DIRECTLINK CONVERSION APPLICATION - REVIEW OF INTERREGIONAL MARKET BENEFITS

**A report to the Australian
Competition and Consumer
Commission**

26 April 2005

Figure 3 Transmission Network NSW - Queensland

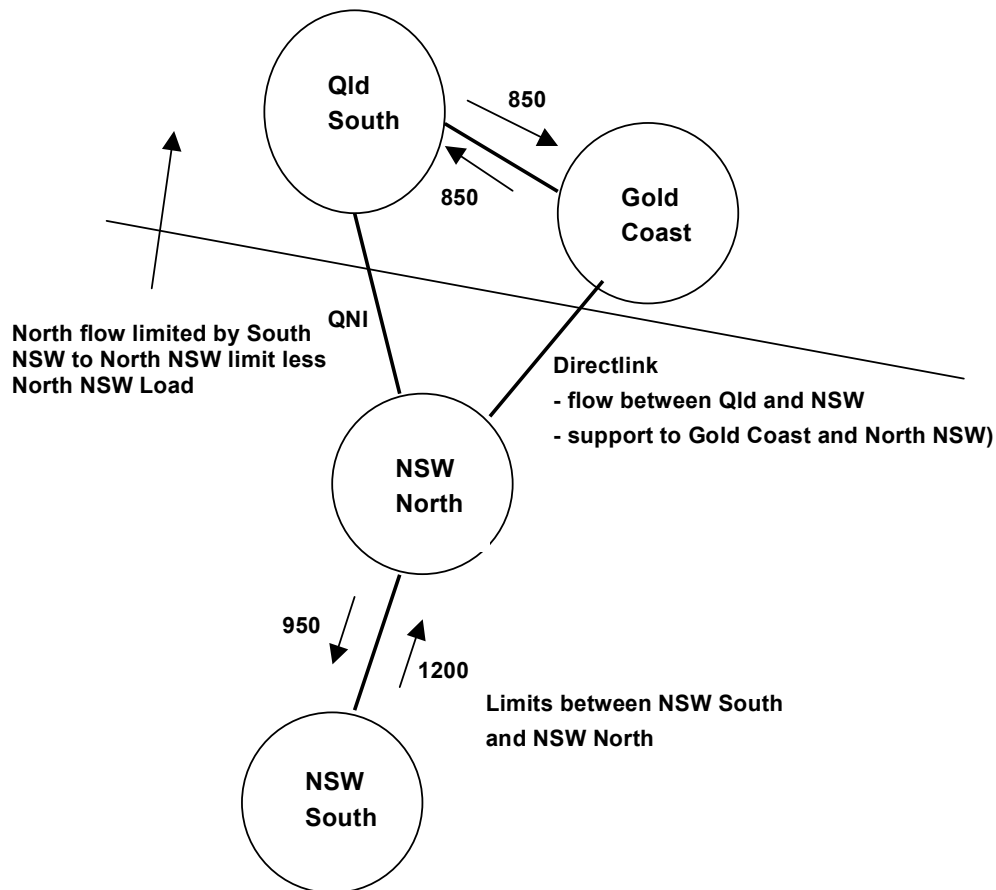
Figure 3 below shows that Directlink adds to the transfer capacity for southward flow but does not add to the transfer capacity for northward flow.

Figure 4 No Project (Alternative Project 5)

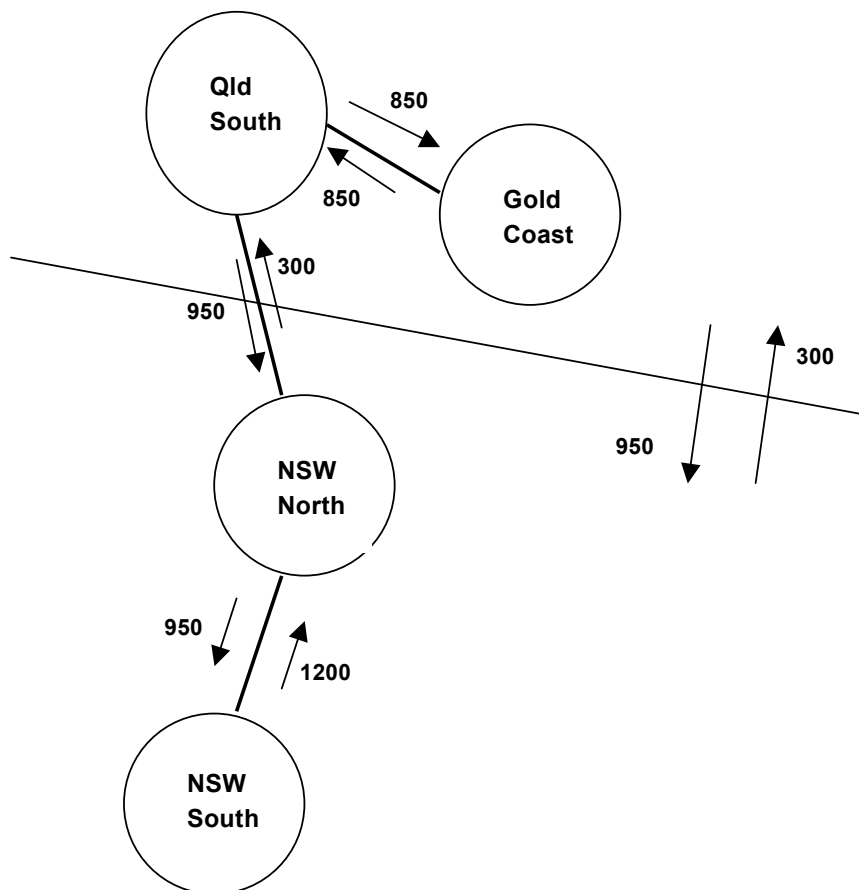
- The maximum flow (at times of high demand) from NSW to Queensland is 300 MW. While this is shown as associated with a capacity constraint on the North NSW to South Queensland line, the limit is actually associated with North NSW to South NSW line;
- For southward flows, the flow on the North NSW to South NSW line will be less than the net south flow QNI + Directlink. This is due to the substantial load in the North NSW area. This means that the North NSW to South NSW line will never constrain flow in the southerly direction.

Figure 5 Alternative Projects 0,1,2,

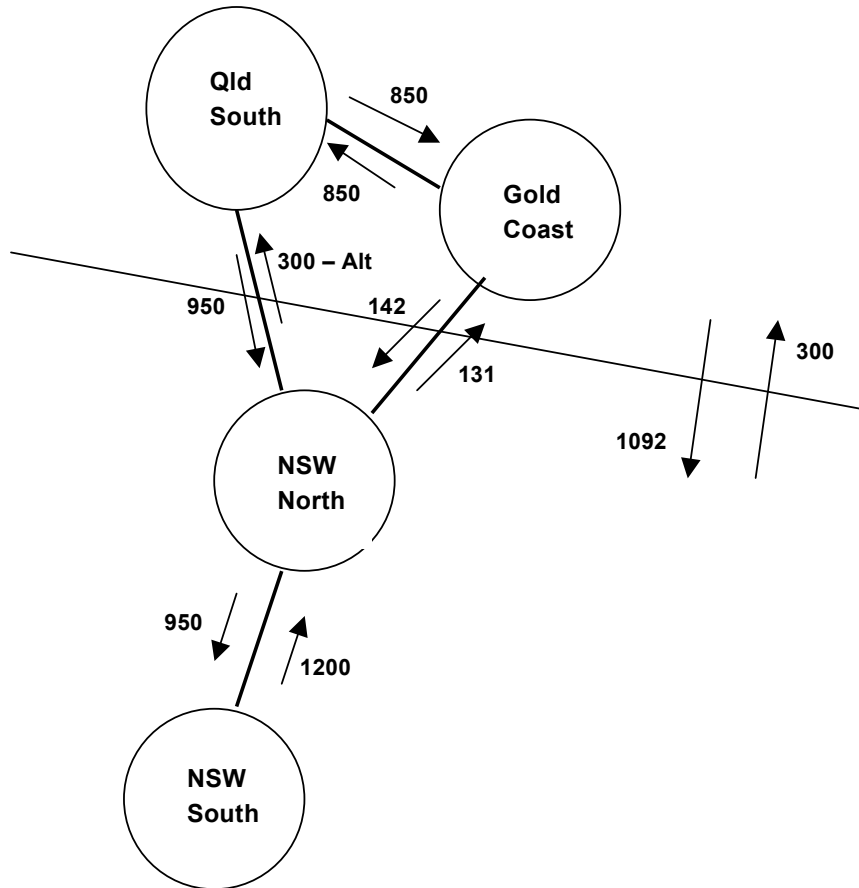
The DJV submission included the economics benefits of Directlink providing transmission support to Northern NSW and the Gold Coast areas (although not simultaneously), with the consequential benefits of deferring required transmission developments in these areas. This requires Directlink to be flowing power to the area being supported during the period support is being provided. This is termed pre-contingent power flow, as it is required in preparation for a potential contingency. Pre-contingent power flow is required as the technology for having Directlink respond after a contingency occurs was not included in the DJV submission.

Analysis showed that the requirement for pre-contingent flow did not impact the capability of Directlink to provide interregional benefits, based on a service level that did not enhance northward flow (ie. NSW to Queensland).

Thus the modelling assumption used by DJV that pre-contingent loading of Alternative Projects 0,1,2 would have no impact on the interregional benefits provided by these projects was considered valid.

Figure 6 Alternative Project 3

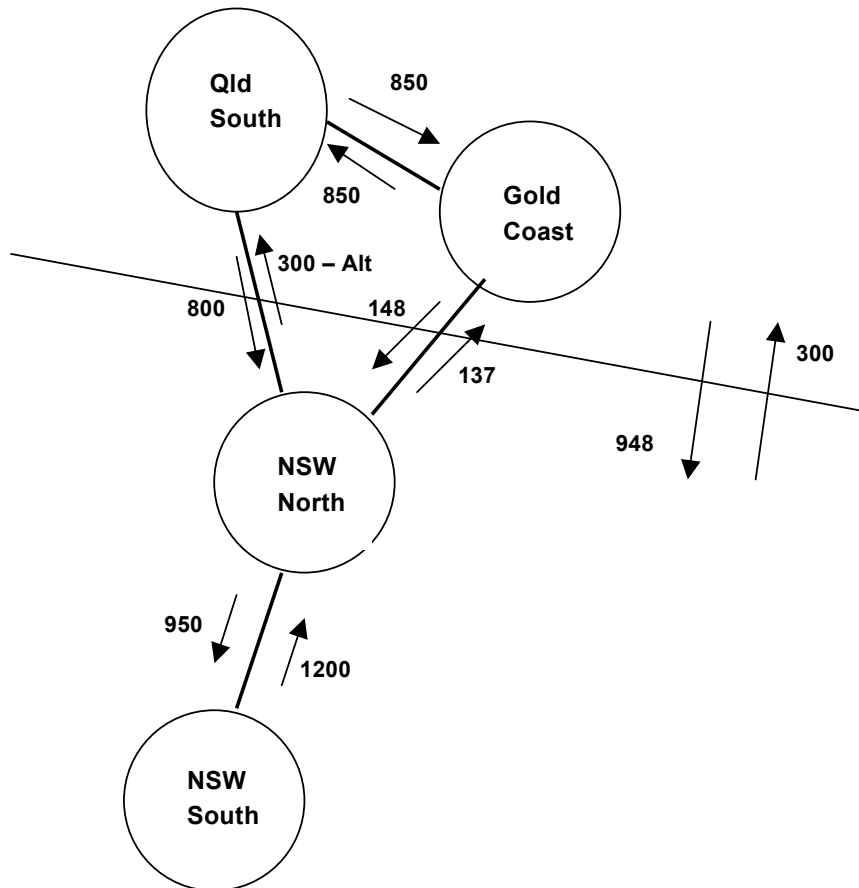
The limits associated with Alternative Project 3 are shown in Figure 6 above. Of note is that this alternative does not provide any increase in (peak demand) interregional capacity. This also applies at all other times.

Figure 7 SRMC Generator Bidding

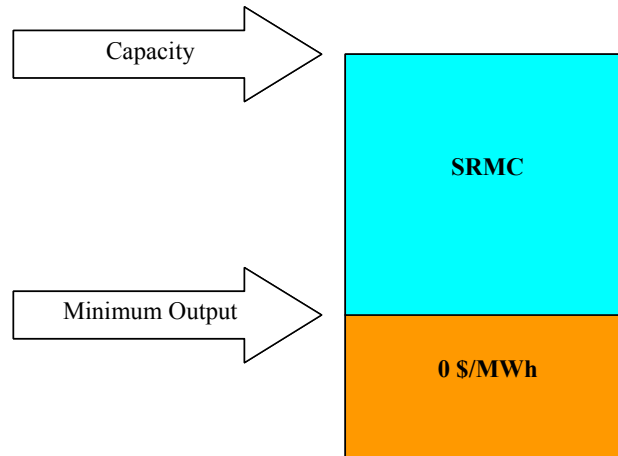
The test requires a scenario that uses SRMC generator bidding. The approach to this that would normally be applied is to have generators bid all of their capacity at SRMC while recognizing the constraints of minimum generation levels. This is shown in the figure below.

It is understood that the TEUS modelling had generators bid their minimum generation levels at \$0/MWh and the rest of their capacity at SRMC. This is consistent with expectation.

Figure 8 LRMC Bidding

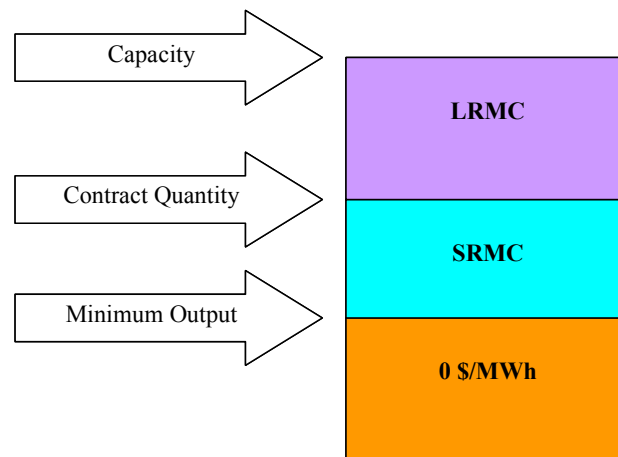
TEUS made no comment on the realism of this bidding scenario in Appendix G, only stating that “This produced market prices sufficiently high to attract coal entry within the first 5 years of the analysis”.

Figure 9 Example of Actual Generator Bids

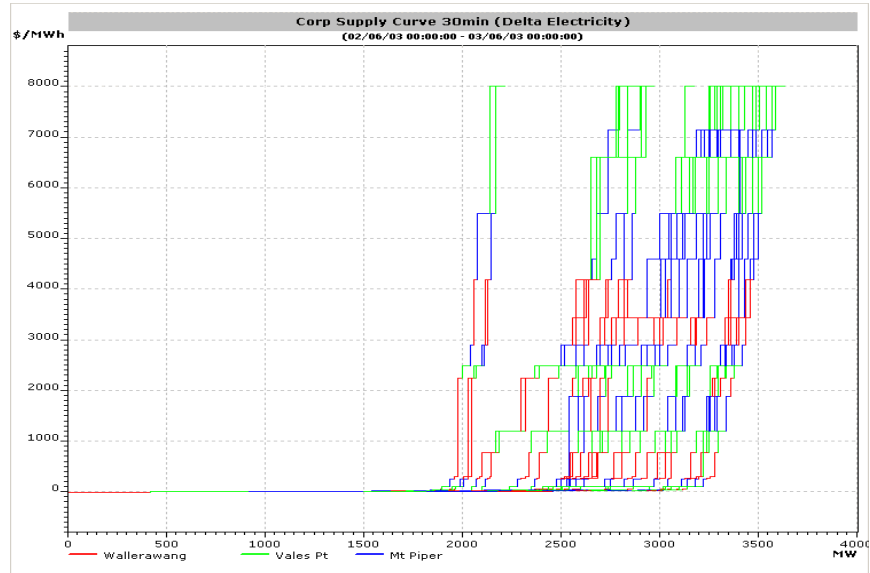
- The type of new entry plant that enters the market depends as much on the distribution of prices (ie. volatility) as on average price levels. Realistic price volatility can only be obtained in the modelling with generator bid shapes that represent those observed in the market. This is bidding at near SRMC to contract levels and then with quickly increasing bid prices. An example of the typical bid curve over a day (ie. 48 bid curves) is shown in the Figure 9 below. The TEUS modelling did not incorporate this characteristic.

the merit order 'on the margin'. On the margin, the dispatch merit order can be significantly different and show greater variation than the dispatch merit order for the total market. The TEUS modelling did not incorporate or investigate this characteristic.

Figure 13 Comparison of TEUS Modelled Spot Prices to Actual NEM Spot Price Outcomes

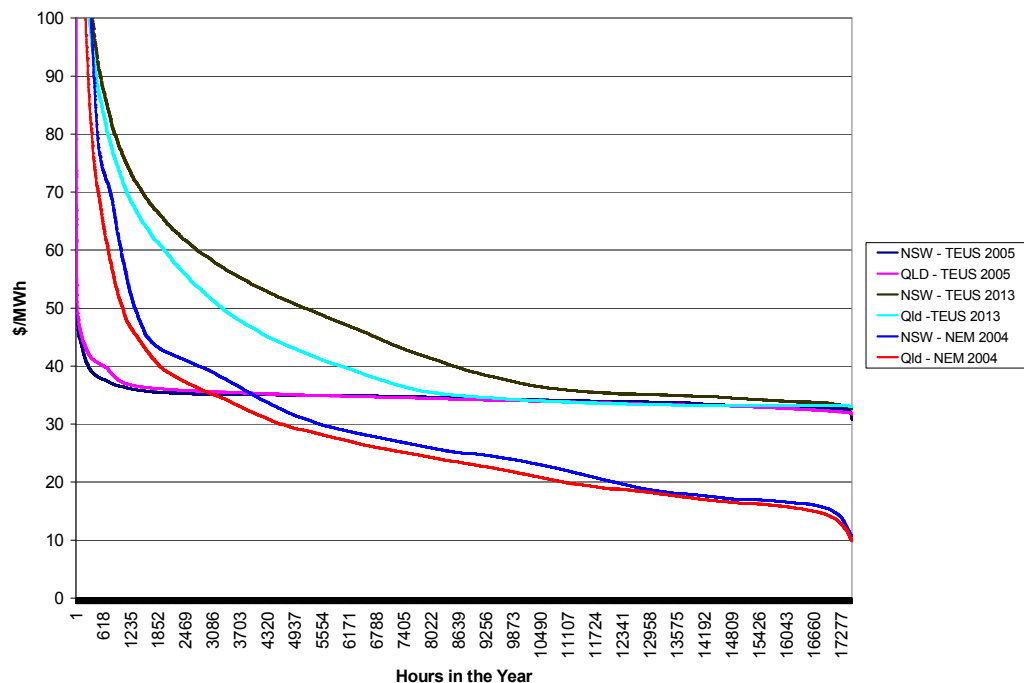
To illustrate this, Figure 13 below presents the price duration curves¹⁹ for NSW and Queensland for the following:

- TEUS modelled prices reflect the LRMC bidding assumption of SRMC + \$20/MWh for existing plant and LRMC for new plant which is very different from the example bid curves illustrated in Figure 9;
